### ONSITE SEWAGE DISPOSAL SYSTEM

P 574135

PROPERTY ADDRESS: 3654 Sharp Road

**From:** Wolf, Kevin  
**Sent:** Friday, May 19, 2023 10:29 AM  
**To:** 'jwalsh@legacyseptic.com'  
**Subject:** 3654 Sharp Road | design spec's  
**Attachments:** [Untitled].pdf

**Picture 1:**

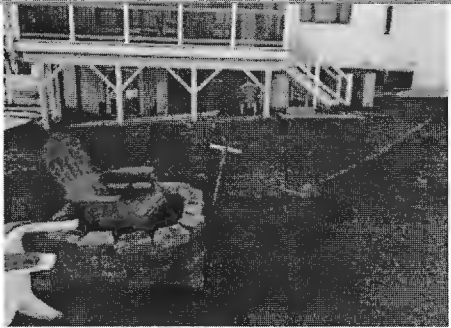
Showing inside the cleanout into the septic tank. Liquid level in the tank was high, backing up into the cleanout and back into the house. Signs of previous high liquid levels observed inside the cleanout

Approved Septic System Plan  
Howard County Health Department

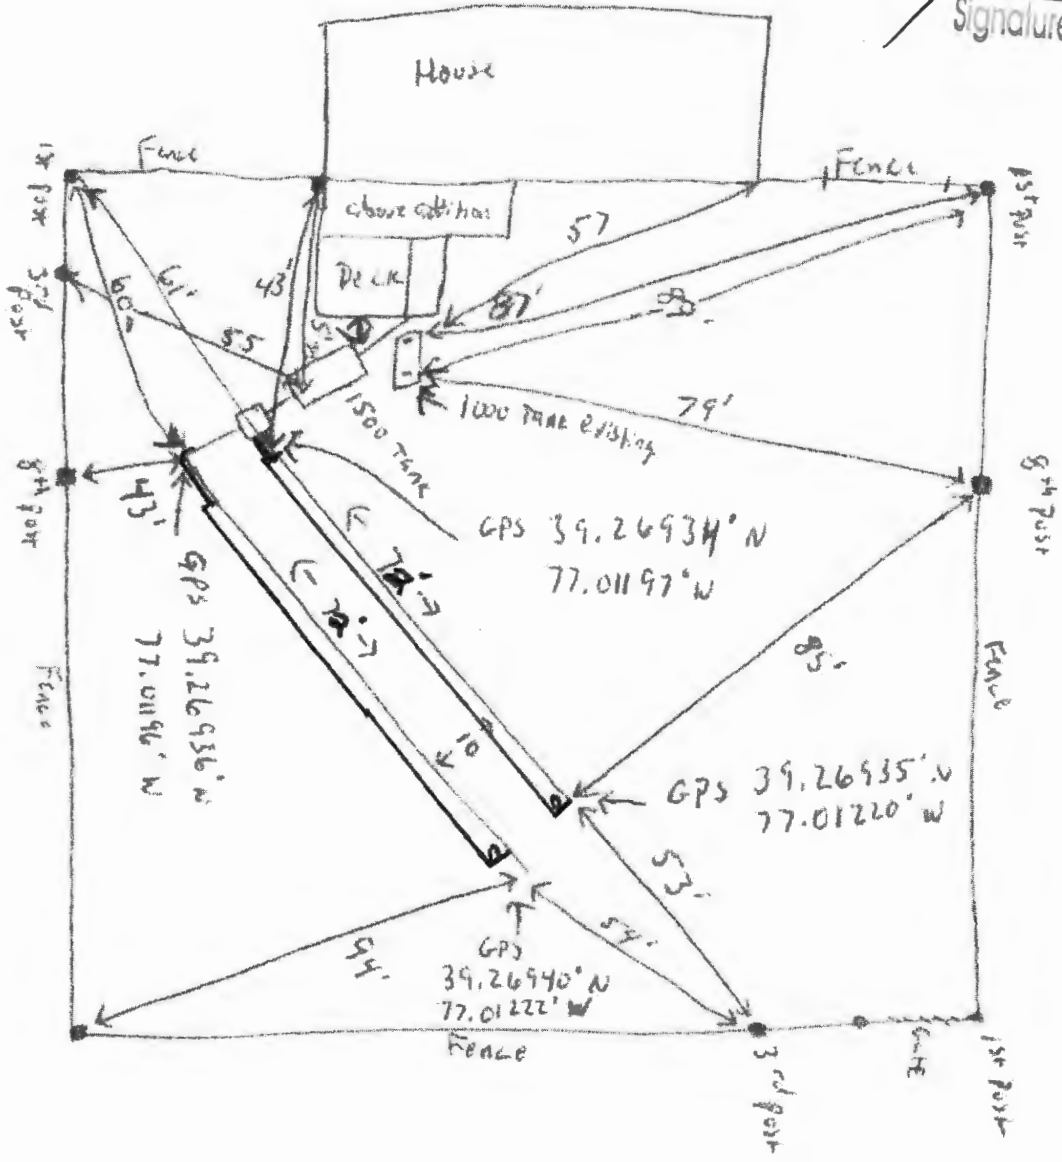
As discussed, please revise site plan to show the trenches as trenches, not lines. Also include all trench spec info as well as the tank info (i.e. manufacture, size, 2 comp., etc.)

The trench specs are as follows:

**Trench length: 143LF (2x72ft)**

**Trench width: 2ft**

**Trench depth: 8ft**

**Trench inlet: \*\*shallow as possible\*\***

**Septic tank: 2 comp. 1500 gallon (4-5BR)**

PLAN VIEW  
SCALE: 1"=40'

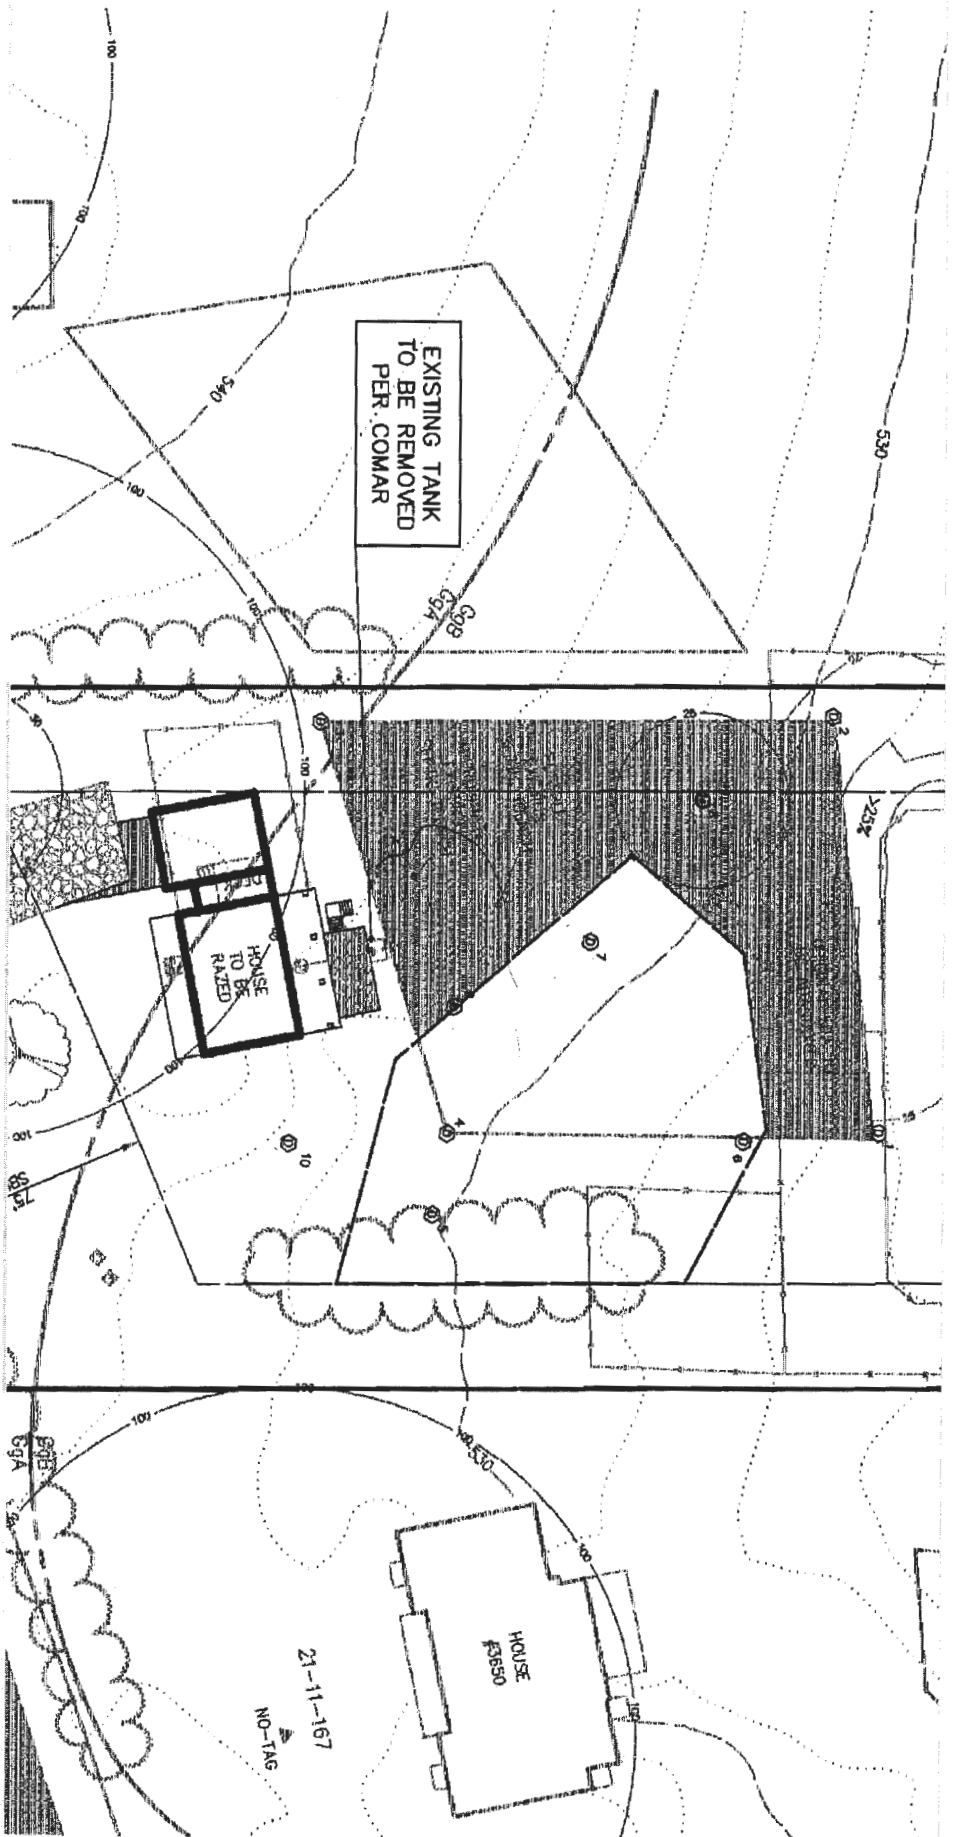
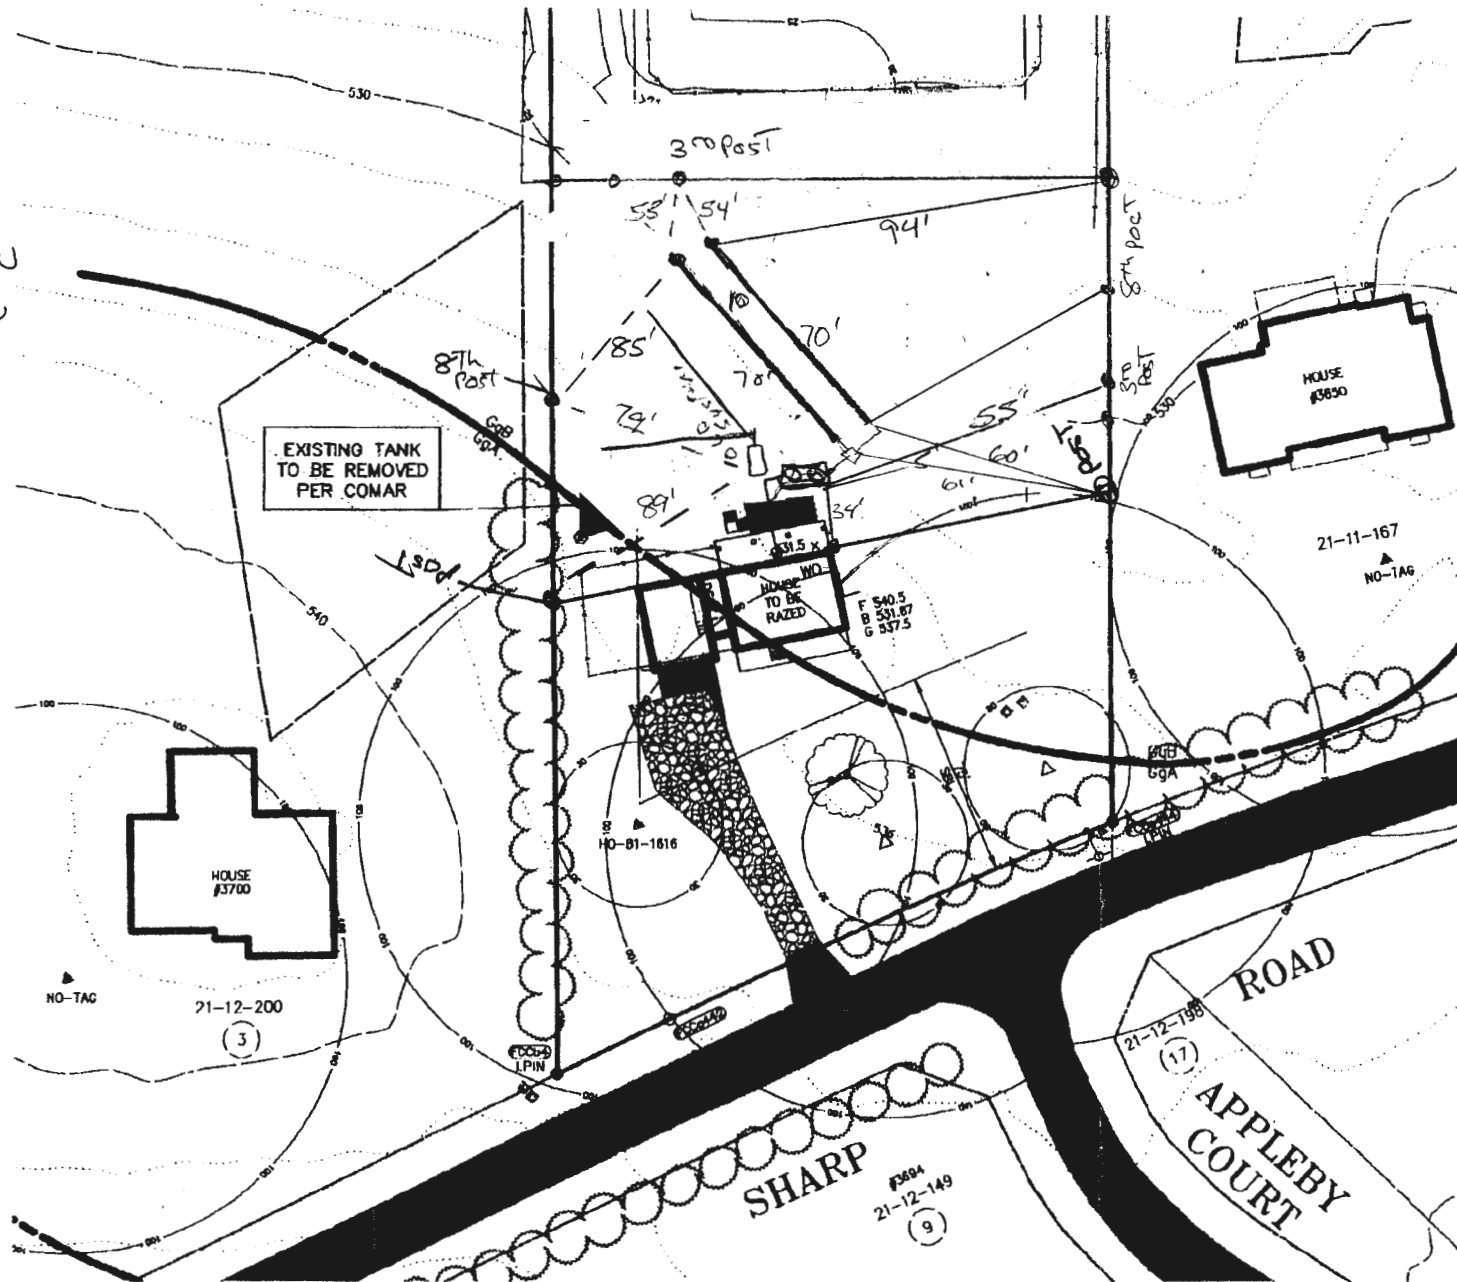
$$\frac{600}{1.2} = 500 \div 2 = 250 (.57) \\ = \underline{143 LF}$$

$$\frac{750}{1.2} = 625 \div 3 = 208 (.62) \\ = \underline{129 LF}$$

Trenches 8  
2' wide

2' x 72'
